Office Action Summary

09/853,276

BLANCHARD, RANDALL D.

DETAILED ACTION

Fig. 1

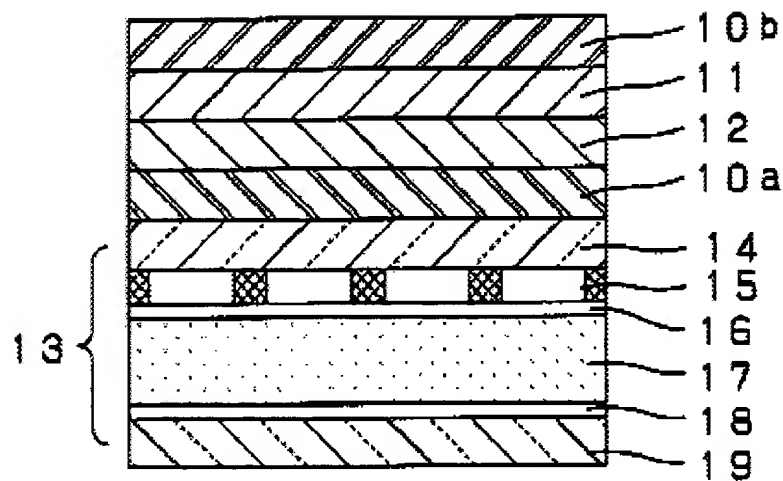
As to claims 1, 2, 5, 11, and 15, Hatanaka discloses in Embodiment 2 (col. 7, line 35 through col. 8, line 20) and Figures 1-3, a liquid crystal display (LCD) comprising:

a liquid crystal cell display screen, 13;

a polarizer, 11 (Applicant's transparent panel), having a backside and an anti-glare front surface configured to diffuse ambient light comprising an anti-reflective layer disposed on the anti-glare front surface (col. 8, lines 1-6); and

a front scattering film layer, 10a (Applicant's bulk diffuser), wherein the bulk diffuser comprises a diffusive material configured to diffuse light within the diffusive material (col. 7, lines 49-67), disposed between the display screen, 13, and the backside, wherein the bulk

diffuser is bonded (col. 7, lines 65-67 and col. 8, lines 3-7) to the display screen and the transparent panel, and

the bulk diffuser is configured to diffuse image light of the display (col. 7, lines 49-67).
